LEVY NUCLEAR PLANT, UNITS 1 AND 2  
DOCKET NOS. 52-029 AND 52-030  
NOTIFICATION OF MODIFICATION SUBMITTED FOR LNP SCA

Pipeline Corridor Comparison Overlay

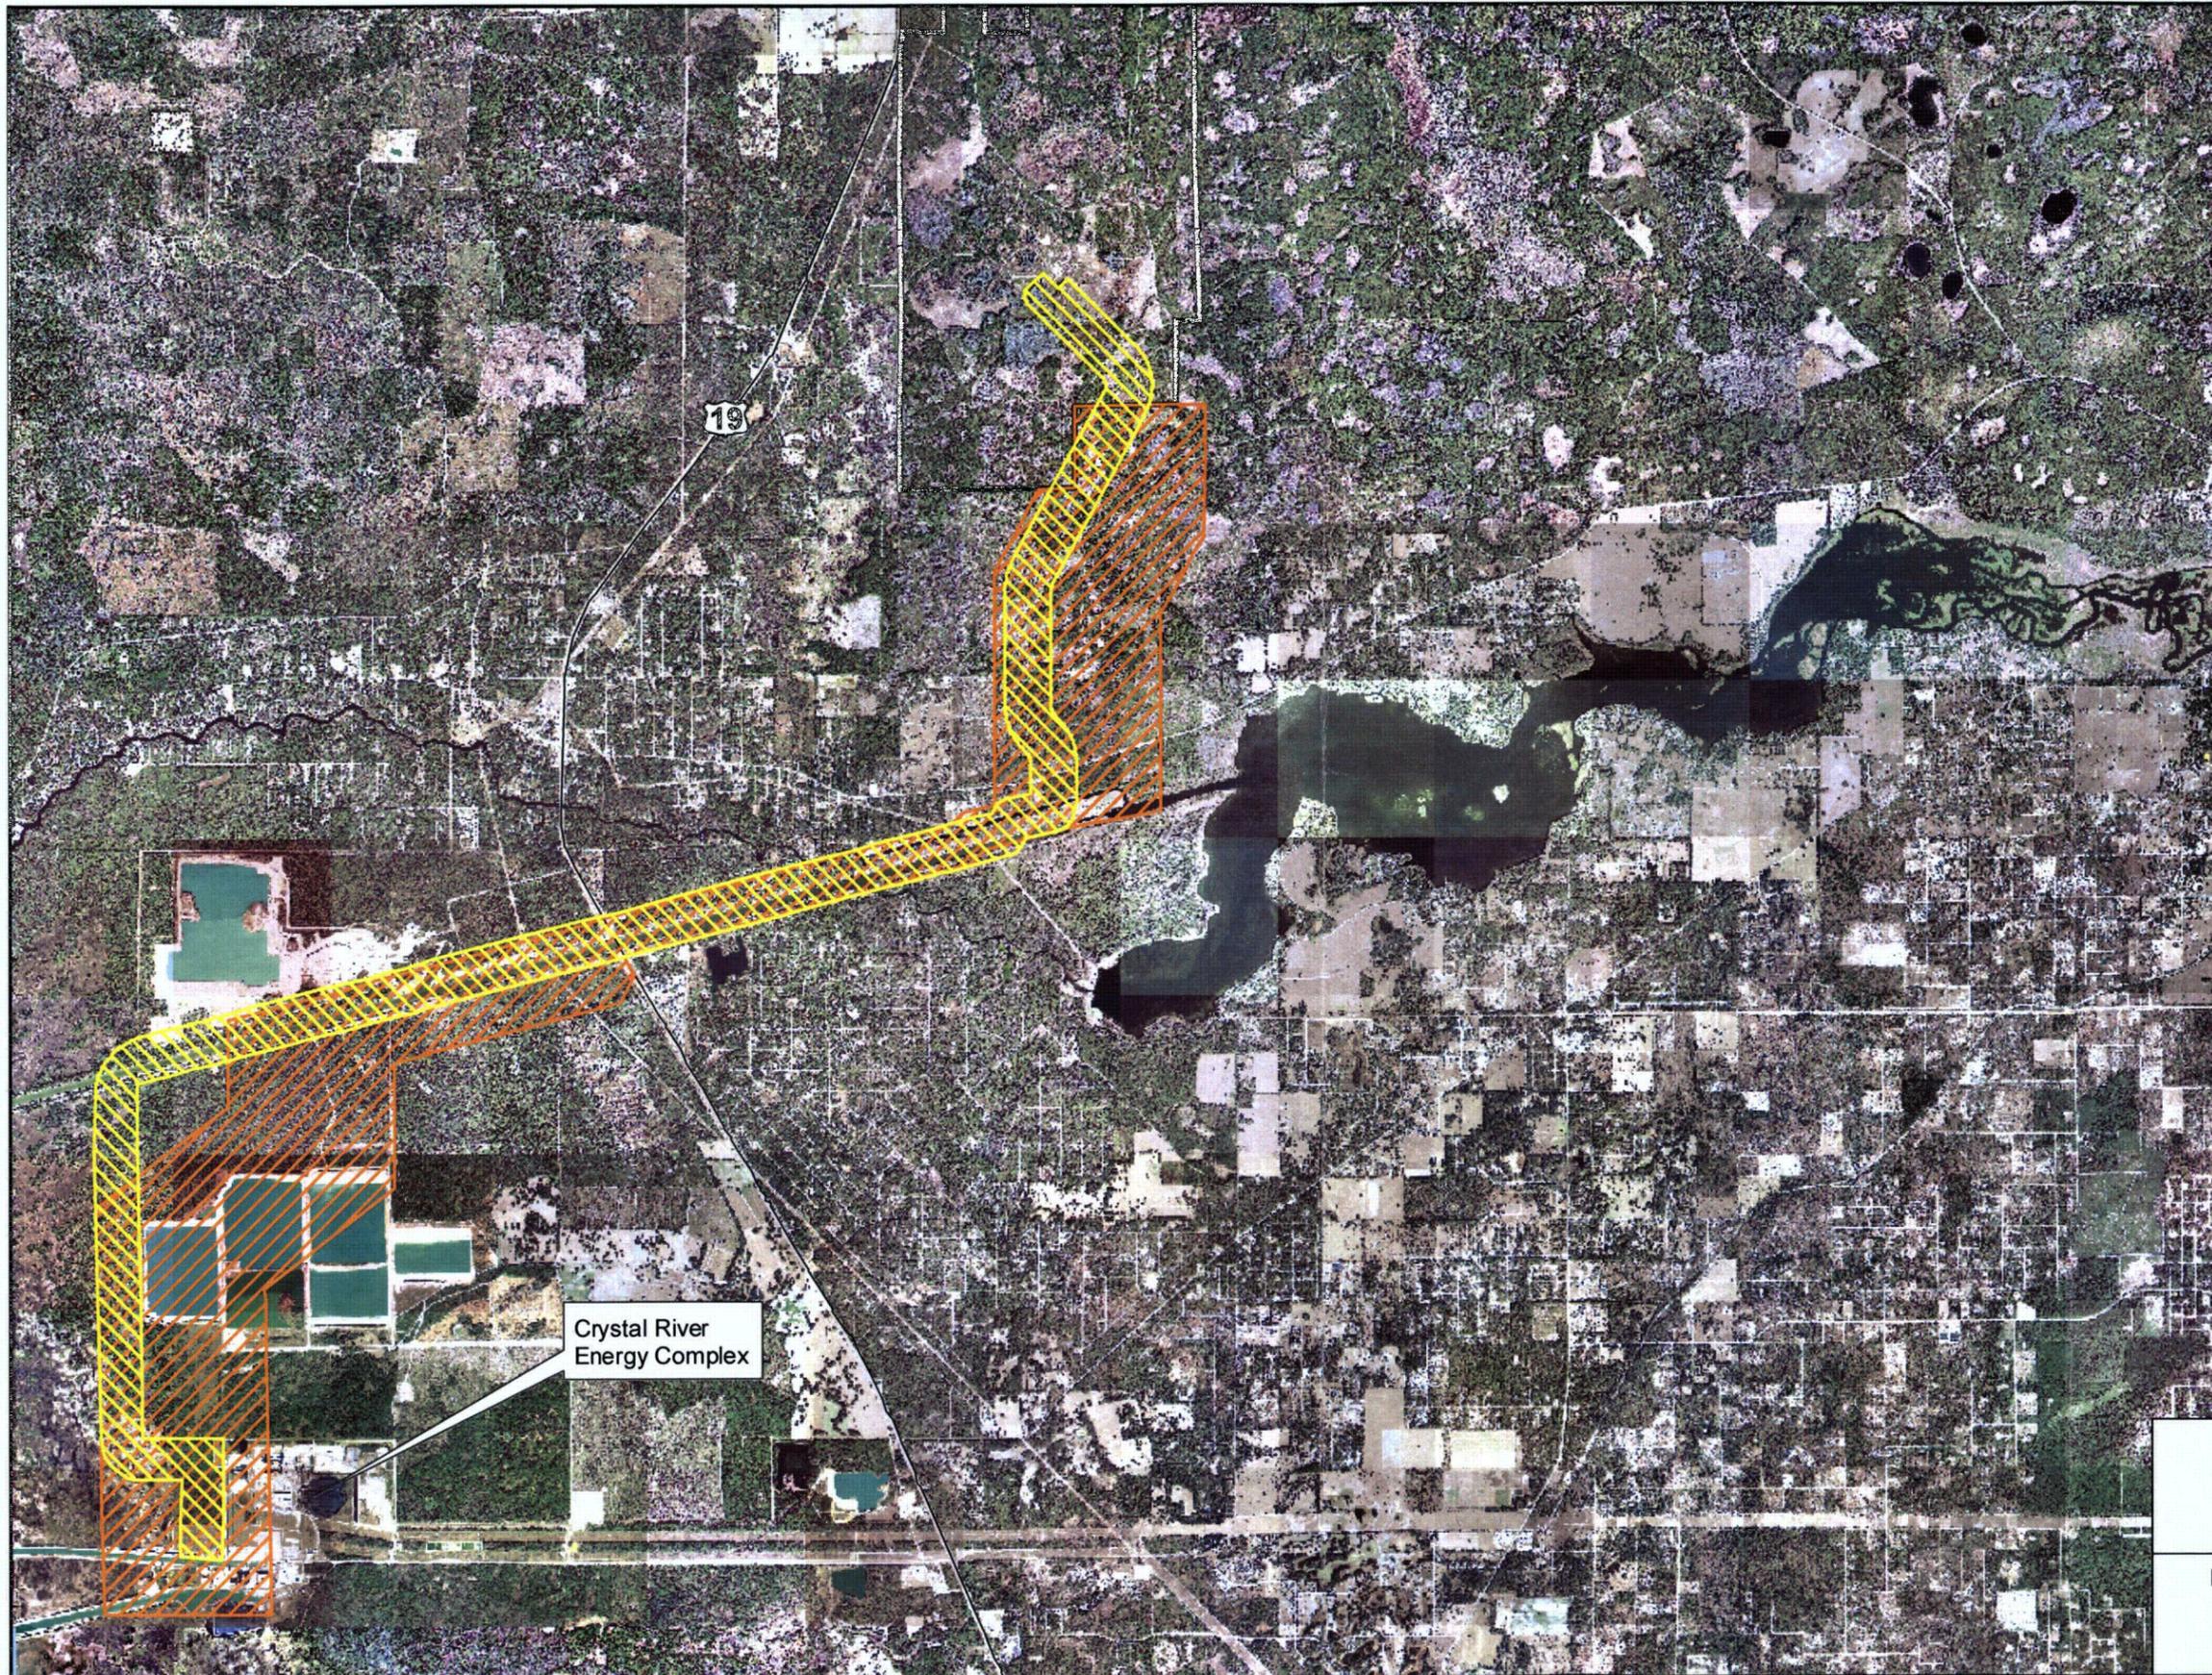
This is to inform you that on April 29, 2010, Progress Energy submitted a petition for modification of the State of Florida's certification pursuant to Section 403.516(1)(c), Florida Statutes, and Rule 62-17.211(1)(b), Florida Administrative Code, for the Progress Energy Florida (PEF) Levy Nuclear Units 1 and 2. The requested modification involves changes to the currently-certified corridor for the heavy haul road, cooling water makeup pipelines and the wastewater/blowdown pipelines to be constructed between the LNP site, in Levy County, Florida, and the PEF Crystal River Energy Complex (CREC) in Citrus County, Florida. A figure showing the currently certified corridor compared to the proposed modified corridor is attached. This modification is requested to provide greater flexibility to minimize impacts to wetlands and other natural resources by locating the final rights-of-way (ROWs) within uplands or lower quality land uses. In addition, the proposed wider corridor provides an opportunity to further minimize disruption of recreational activities along the Cross Florida Barge Canal (CFBC) and to reduce the use of state-owned lands along the CFBC. The final ROW widths within the corridor will remain the same.

It is not expected that the proposed modification of this corridor will result in any greater adverse environmental effects than would occur within the existing certified corridor for the heavy haul road and water pipeline facilities. The length of the entire corridor will remain at approximately 13 miles, but its width in certain places will increase 0.75 miles, for a total width of up to 1 mile, as described above. While the width of the corridor will increase in some locations, the final rights-of-way for each of the facilities within the corridor, as identified in the original Site Certification Application (SCA), will not increase as a result of this modification.
